## Stellaris® LM3S9B92 RevC3/C5 Errata

This document contains known errata at the time of publication for the Stellaris LM3S9B92 microcontroller. The table below summarizes the errata and lists the affected revisions. See the data sheet for more details.

Figure 1.  $V_{DDC}$  and  $V_{DD}$  Rise Time Relationships

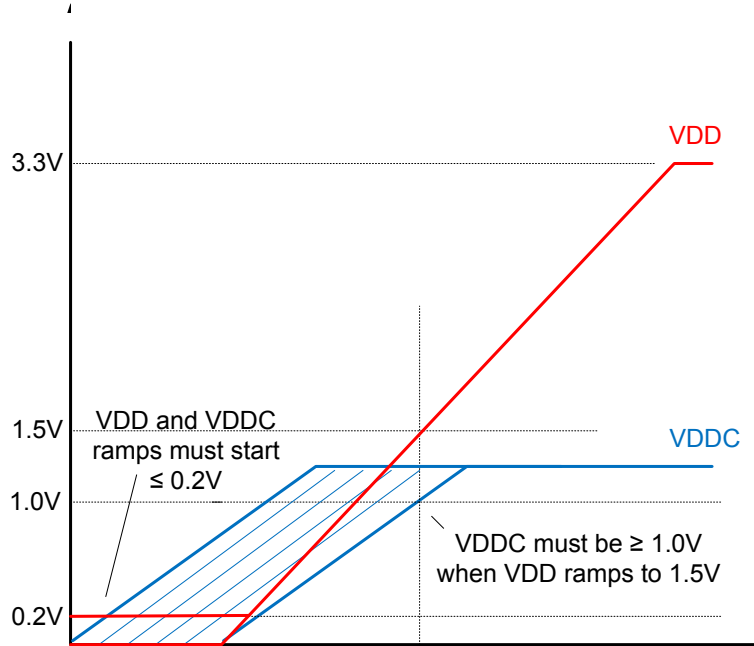
There is a small risk of flash corruption or device failure on power up. The issue can occur with certain  $V_{DD}$  and  $V_{DDC}$  power sequences. The failure is not in the flash memory itself but in the control logic to the flash.

- The ramp of both  $V_{DD}$  and  $V_{DDC}$  must begin below 0.2 V.
- $V_{DDC}$  must reach at least 1.0 V before  $V_{DD}$  rises above 1.5 V.

Figure 1 on page 11 details these requirements. Three workaround circuits have been identified that meet these requirements and are described below.

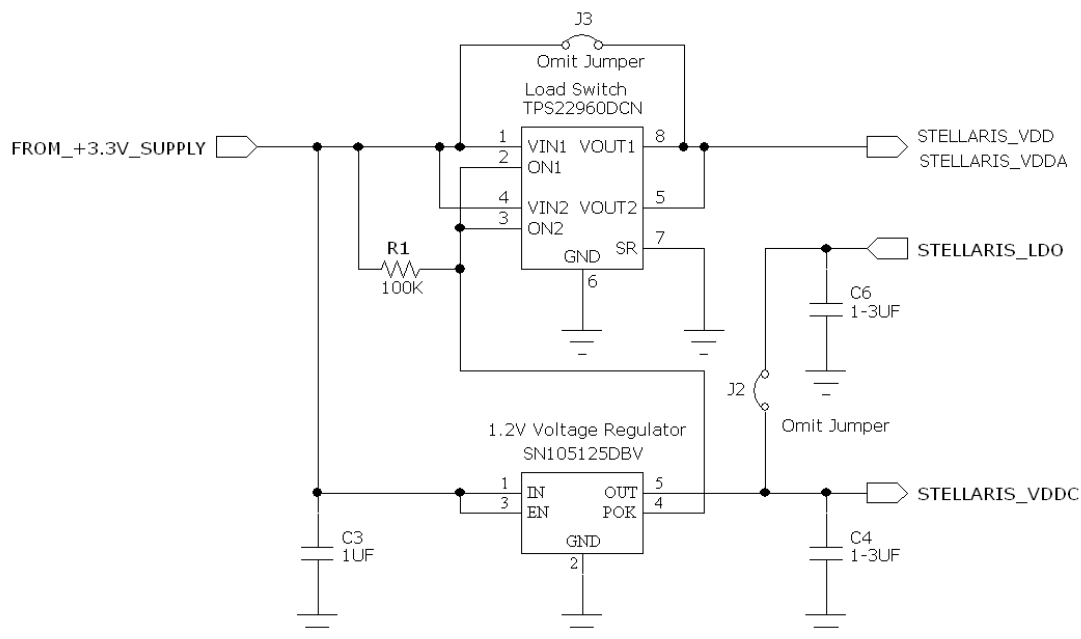
Three recommended circuits that eliminate the occurrence of this issue are shown below. Although the LDO regulator output is unused in the workaround circuit, a capacitor (1-3  $\mu\text{F}$ ) must remain connected for regulator stability. In addition, the  $\text{LDO}$  pin of the Stellaris device must be disconnected from the external 1.2 V LDO to prevent electronic over stress of the pin. All of these circuits include two jumpers which must be implemented to bypass the workaround circuit for future silicon revisions.

Figure 2 shows a small chip-scale load switch to control  $V_{DD}$ . This circuit is suitable for  $V_{DD}$  current up to 2 A peak.

**Figure 5. Example of USB Certification Failure**

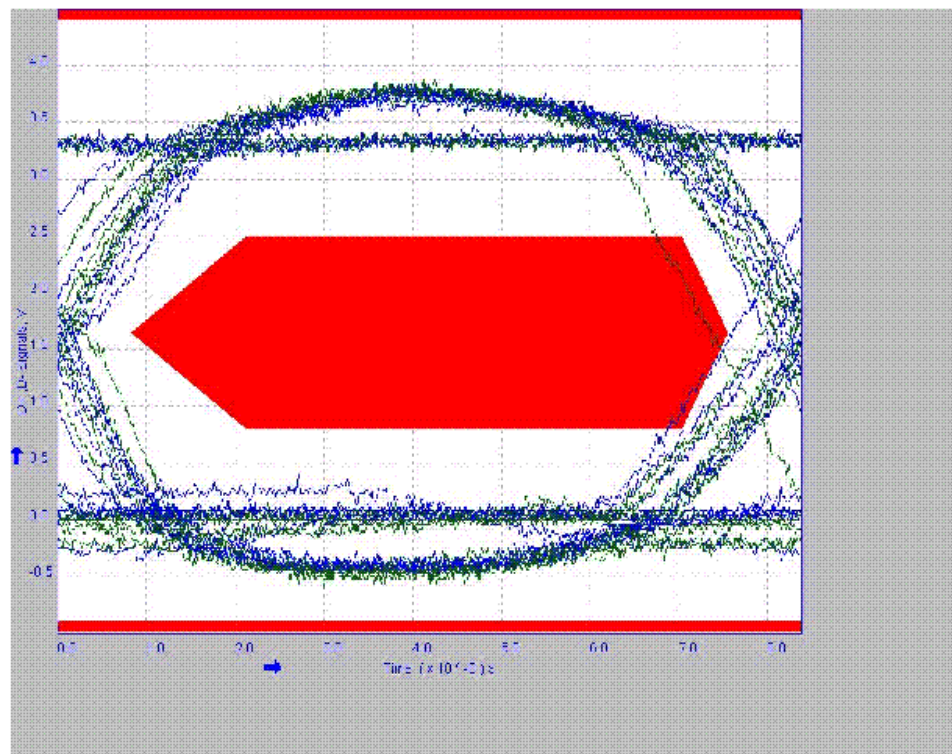
If the EPI module is operating, the USB interface may fail USB certification. Failures have been seen for the eye diagram and jitter (see Figure 5 on page 25). Because of these issues, there is a potential for data corruption on the USB interface when using the USB and EPI at the same time. The risk of data corruption is small, but is dependent on the system design.

- Signal eye:  
Eye Diagram Test fails

- EOP width: 169.0995ns  
EOP width passes
- Receivers: reliable operation on tier Tier 6  
Receivers pass
- Measured Signalling Rate: 11.92707Mbps  
signal rate conditionally passes
- Crossover voltage range: 1.546667 V to 1.680000 V  
Mean crossover = 1.615889 V  
First crossover at 1.660000 V(11 other differential crossovers checked)  
crossover voltages pass
- Consecutive jitter range: -165.1885ns to 1.811468ns, RMS jitter 52.27256ns  
Paired JK jitter range: 752.3810ps to 2.871429ns, RMS jitter 1.821542ns  
Paired KJ jitter range: 1.185714ns to 2.168571ns, RMS jitter 1.695397ns  
jitter fails

USB certification can be attained if an application does not require the USB and the EPI to be operating simultaneously. Customers who do not intend to pursue USB certification should determine if their application can handle the resulting small amount of error.
